UNITED STATES
NUCLEAR REGULATORY COMMISSION
WASHINGTON, D. C. 20555

February 7, 1991

SUBJECT: BACKFIT CLAIM RELATED TO THE STATION BLACKOUT EVALUATION FOR
PEACH BOTTOM ATOMIC POWER STATION, UNITS 2 AND 3 (TAC NOS.
79371 AND 79372)

PLANT-SPECIFIC BACKFIT DETERMINATION REGARDING
STAFF POSITIONS RELATED TO STATION BLACKOUT EVALUATION FOR
PEACH BOTTOM ATOMIC POWER STATION, UNITS 2 AND 3

Figure 1

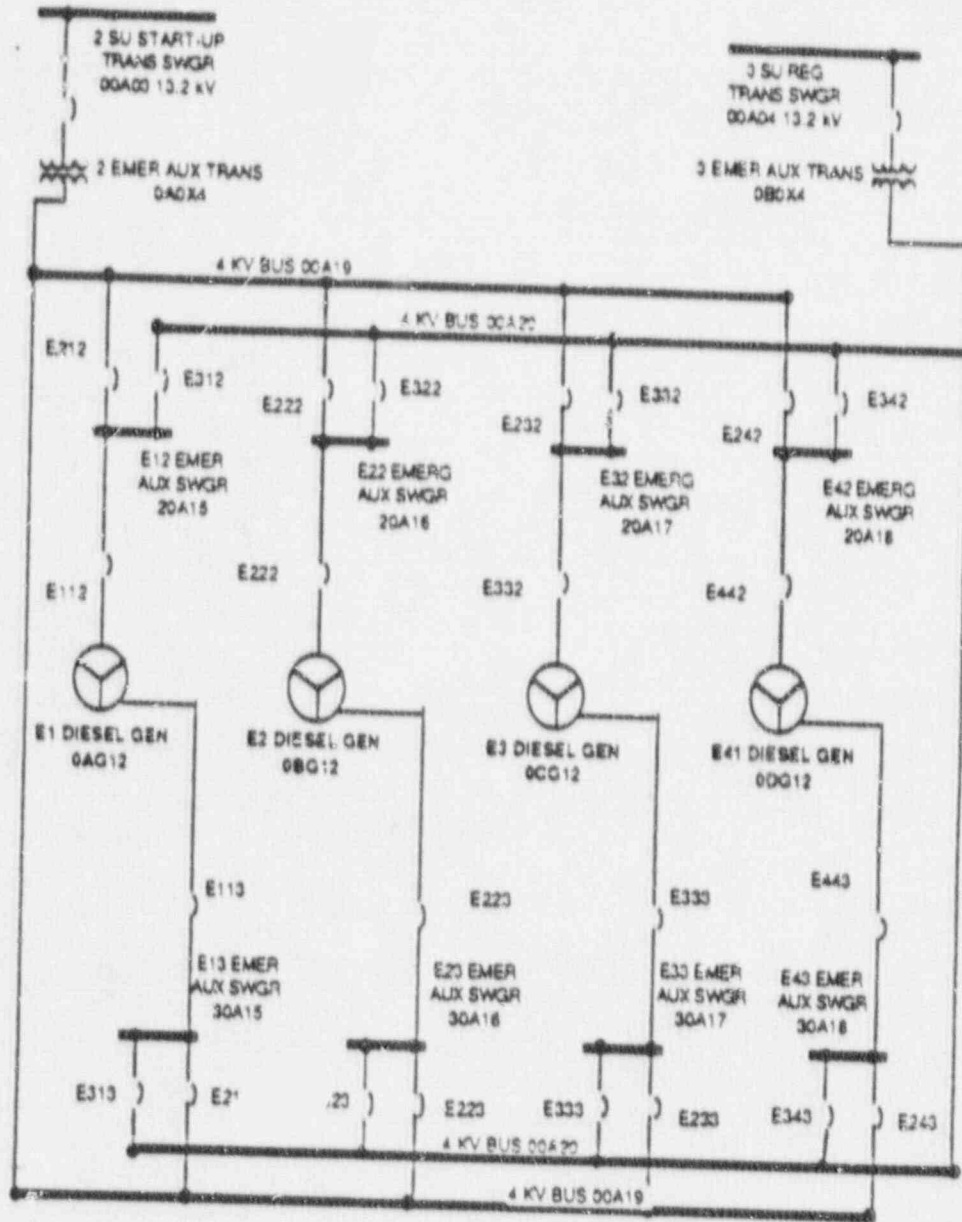
The Peach Bottom Atomic Power Station (PBAPS) is a two-unit station with four emergency diesel generators (EDGs) shared by the two units (Figure 1). The PBAPS updated final safety analysis report (UFSAR) discusses the ability to safely shut down both units assuming operation of three of the four EDGs during a station-wide loss of offsite power (LOOP) event and a concurrent design basis loss of coolant accident (LOCA) at one unit. The UFSAR does not include an analysis to determine the minimum number of EDGs required to safely shut down both units during a station-wide LOOP event without a concurrent LOCA at one unit. The licensee claims that two EDGs are sufficient, whereas the NRC staff has determined that three EDGs are required. The rule and the

The asymmetry of the safe shutdown loads on each 4 kV emergency bus may prevent the connection of any two EDGs so as to power all of the needed LOOP safe shutdown loads for both units. In addition, the existing EDG configuration provides connectibility of each EDG to only one of the four safety buses in each unit. Thus, this limitation of connectibility may prevent any two buses from providing the design complement of loads for LOOP safe shutdown. Therefore, the staff concludes that three EDGs (instead of two) are needed to power the LOOP shutdown loads for both units and four EDGs meet only the minimum redundancy requirements. Therefore, the PBAPS configuration contains no excess redundancy for permitting the use of one of the existing four EDGs as an AAC power source.
